# Access Compliance Report

## Public Rights-of-Way

Intersection ID: 10028571	Main Street: HOLLYBUSH_LN	Cross Street: N/A	Location: NE
ADA ID: 44557FB4695F	Ramp Type: Perp	Initial Pass/Fail: Fail	Overall Compliance: No
Severity Score: 46.25			
Codes/Mitigation Info/Possible Solution		Field Measurements/Component Compliance

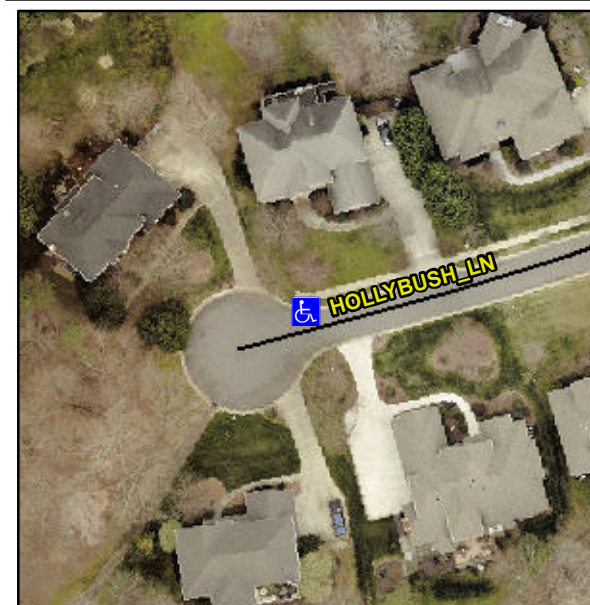
**Not Found, R304.5.1, R304.2.2, R304.5.3**

Compliance	Description	Data	Compliance	Description	Data
N/A	Ramp Length (in)	96.0	No	Ramp Slope (%)	8.9
No	Ramp Width (in)	47.0	No	Ramp XSlope (%)	11.9
N/A	Flare Type LT	N/A	N/A	Flare Type RT	N/A
N/A	Flare Slope LT (%)	N/A	N/A	Flare Slope RT (%)	N/A
N/A	Flare Traversable LT?	N/A	N/A	Flare Traversable RT?	N/A
N/A	Landing Length (in)	N/A	N/A	DWS Provided?	N/A
N/A	Landing Width (in)	N/A	N/A	DWS Contrast?	N/A
N/A	Landing Slope (%)	N/A	N/A	DWS Length (in)	N/A
N/A	Landing X Slope (%)	N/A	N/A	DWS Full Width?	N/A
N/A	Landing Curb? (Y/N)	N/A	N/A	DWS Offset (in)	N/A
N/A	Shared Landing?	N/A			
N/A	Gutter Ponding?	N/A	N/A	Gutter Slope (%)	N/A
N/A	Gutter Lip Ht (in)	N/A	N/A	Gutter X Slope (%)	N/A
N/A	Painted X Walk1?	No	N/A	Painted X Walk2?	N/A
	X Walk 1 Direction	To S		X Walk 2 Direction	N/A
N/A	X Walk 1 Width (in)	N/A	N/A	X Walk 2 Width (in)	N/A
	X Walk 1 Slope (%)	1.3		X Walk 2 Slope (%)	N/A
	X Walk 1 X Slope (%)	8.9		X Walk 2 X Slope (%)	N/A

**Remove & Replace Entire Ramp.**
